**PLAN COMMISSION
MEETING NOTICE AND AGENDA
Thursday, September 20, 2018
7:00 PM**

Date: September 4, 2018
To: Scott Klein, City Administrator
From: Nick Fuchs, Wrayburn Consulting, LLC
RE: Swan Farm Property (Westridge Builders) Preliminary Plat/Subdivision
Development Review

C1.0

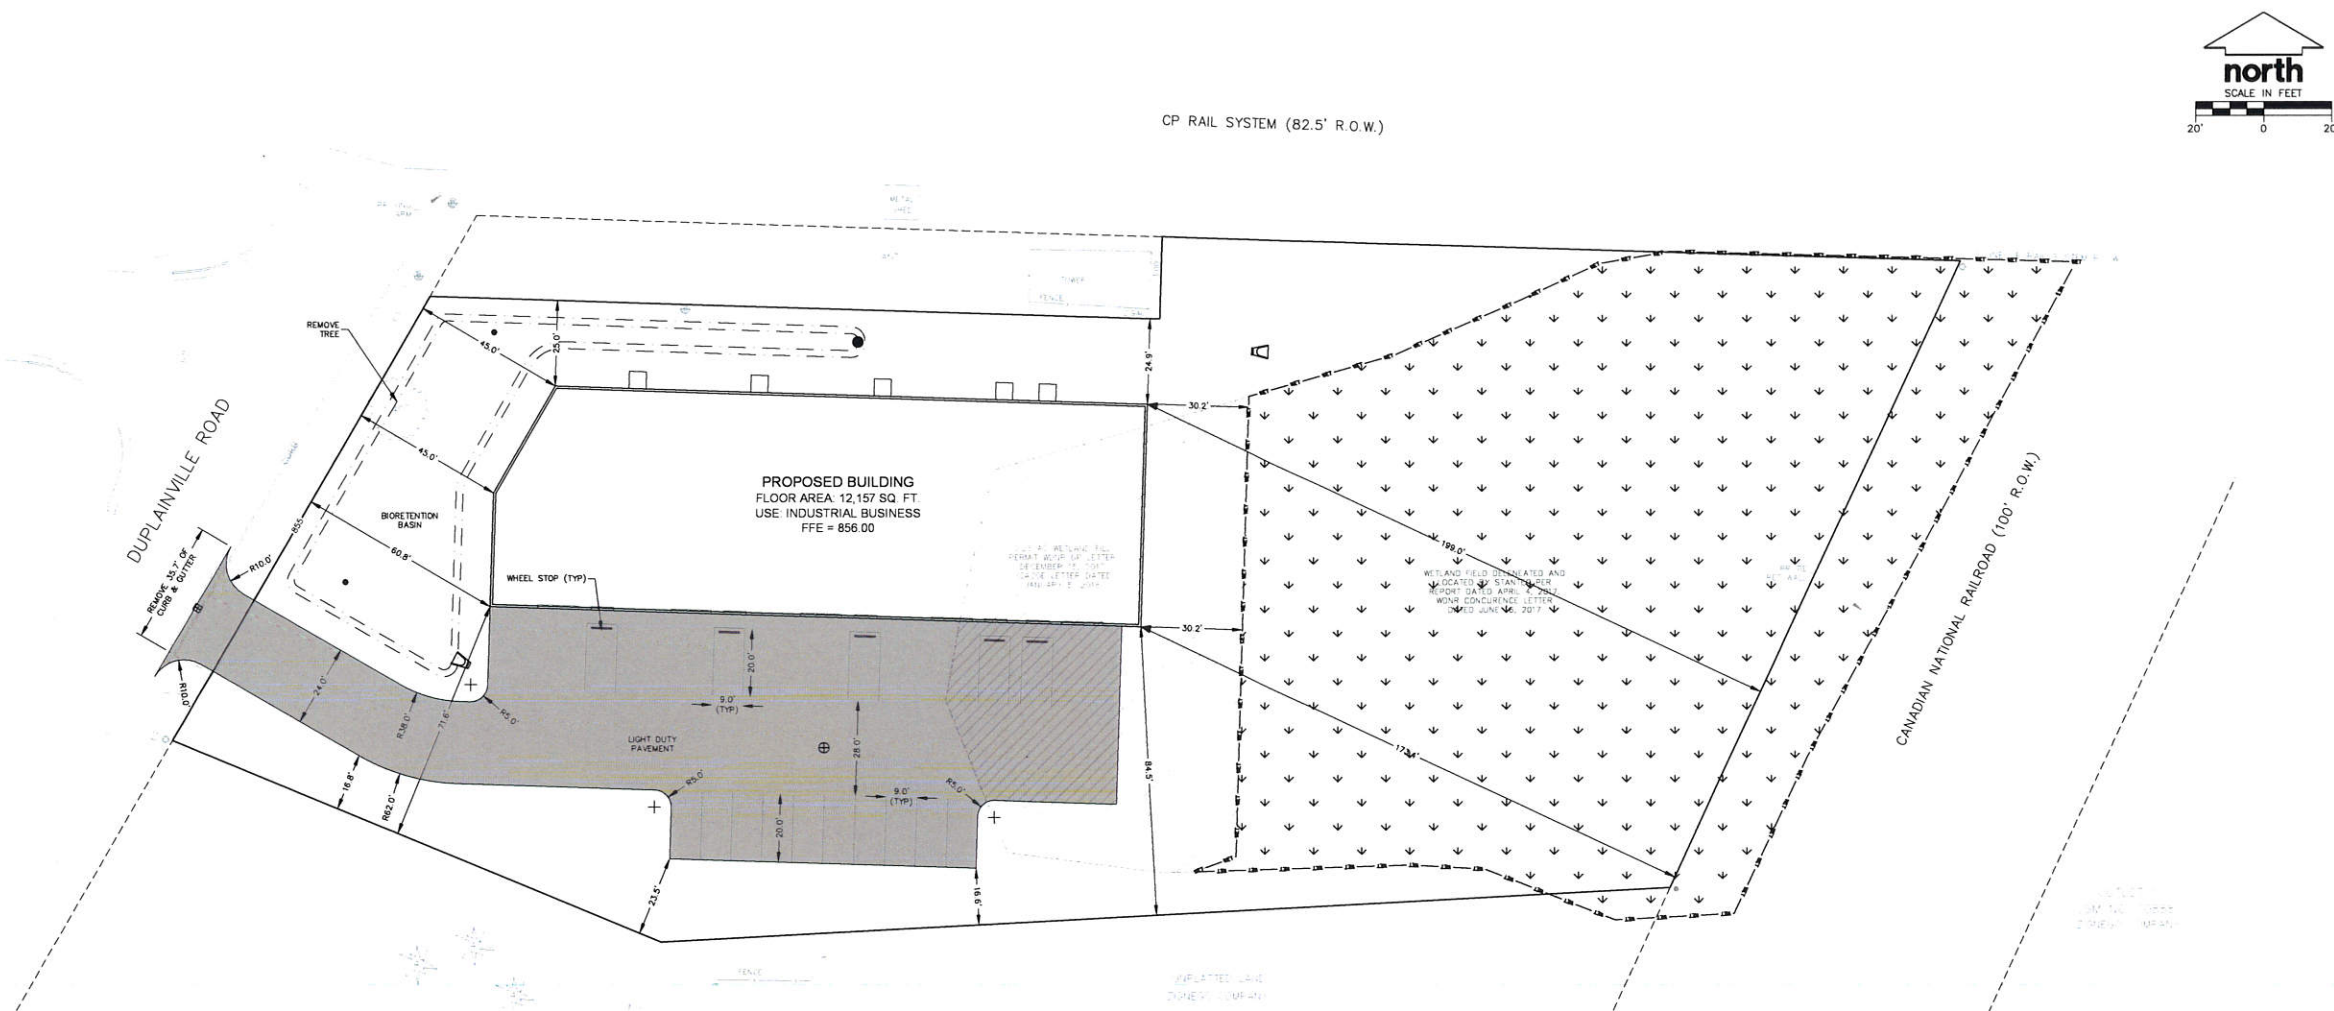
As illustrated on the Existing Site Plan (Sheet C1.0), a wetland is located on the east half of the property. The applicant has received Wisconsin Department of Natural Resources approval to fill approximately 0.23 acres of that wetland. Otherwise, no Southeastern Wisconsin Regional Planning Commission Corridor, floodplain or other protected natural resource exist onsite.

.A1.0

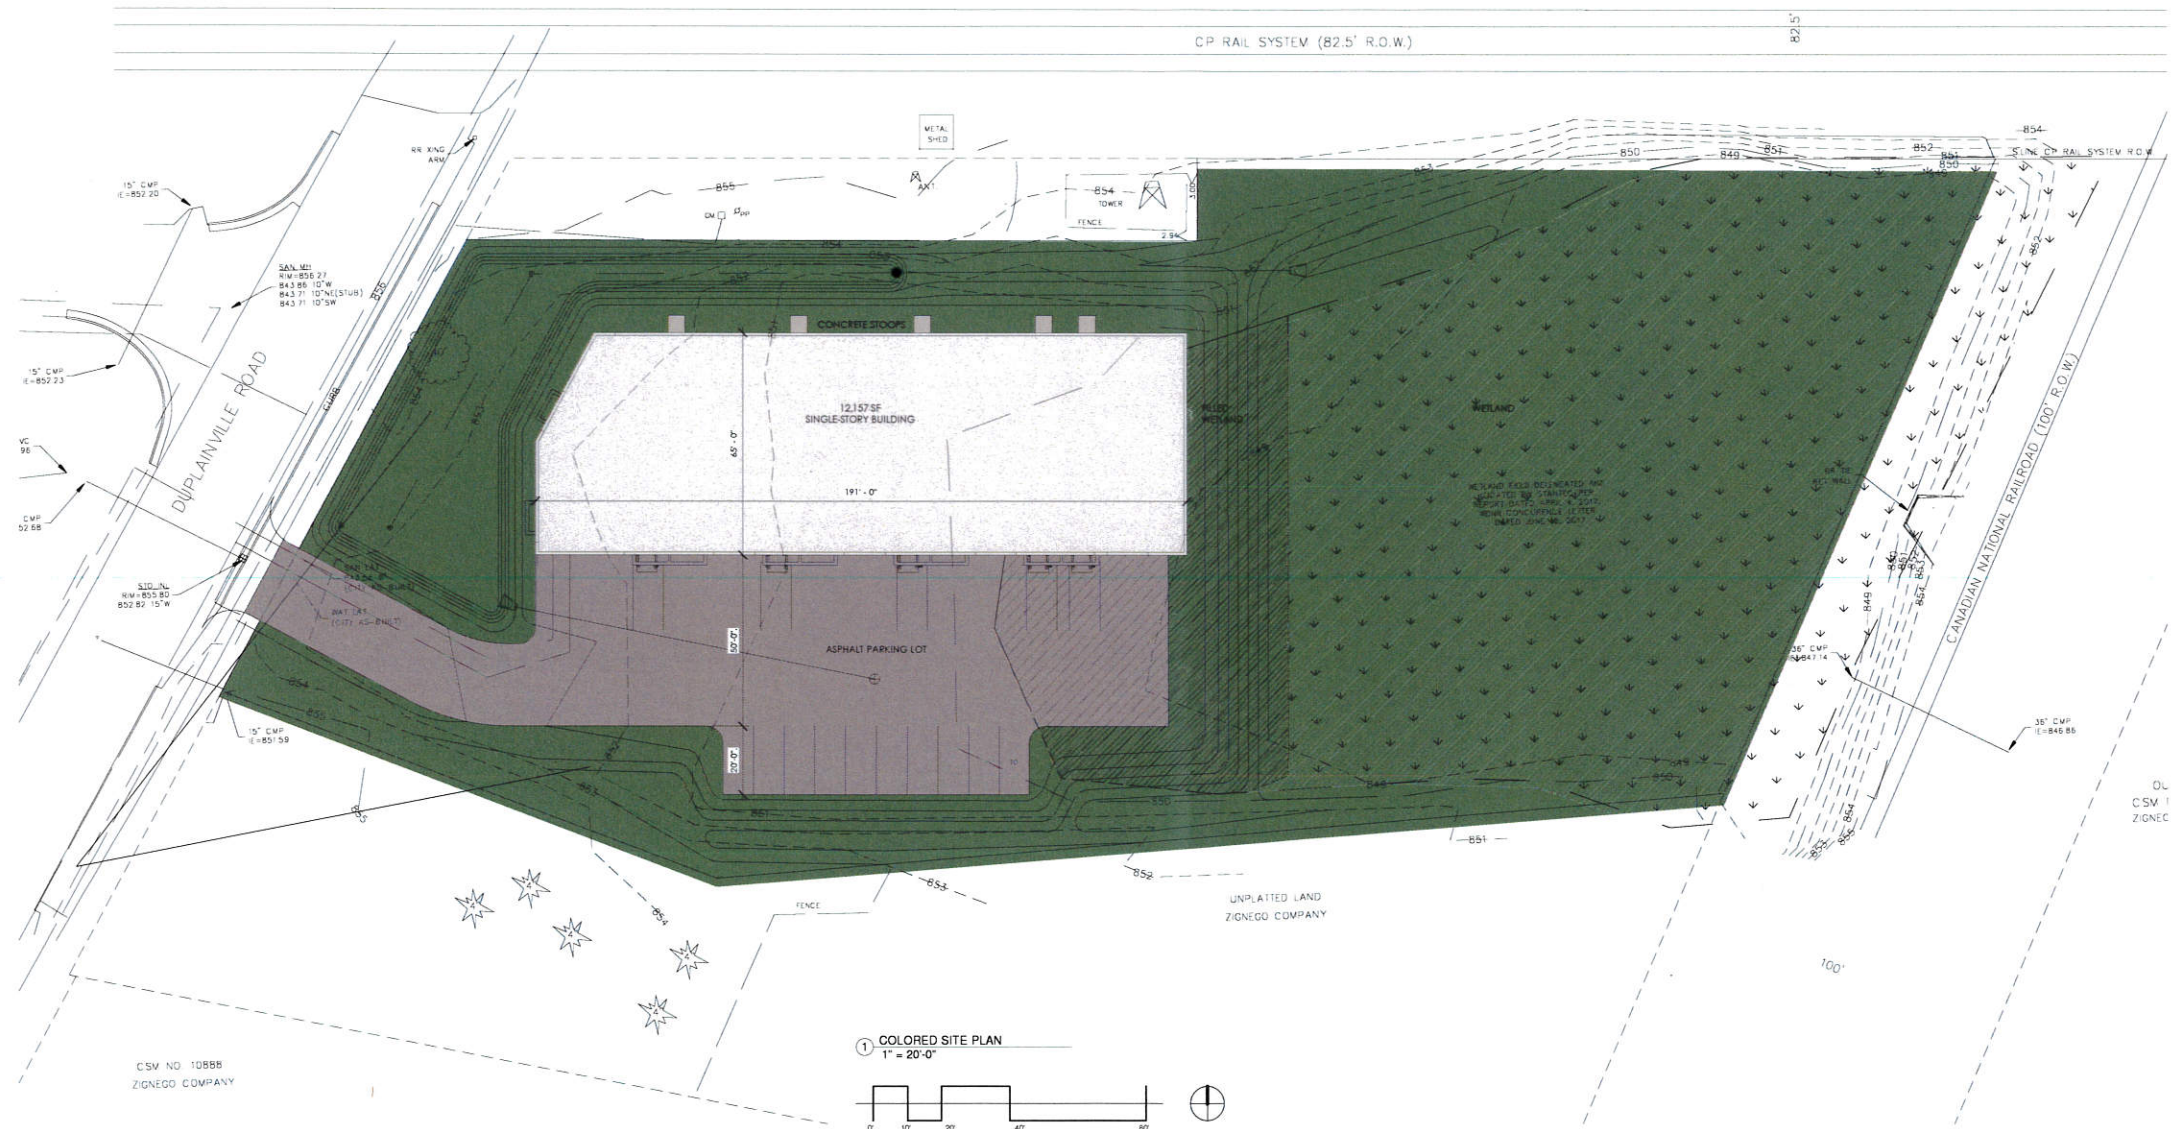
7. Sheet A1.0 indicated the proposed building as "Phase 1." Is there a planned Phase 2 for the property?
8. Please label the setback from the wetland on the Site Plan. A minimum 25-foot setback is required.

9. Please label the nearest driveway setback to the south property line.
10. Please include more detailed site calculations on Sheet A1.0, such as the total site size (square feet and acres), wetland fill in square feet, and the actual percentages of greenspace and impervious surface proposed. Note that 40% greenspace is required and only 20% of the remaining wetland area may count towards greenspace. See below.
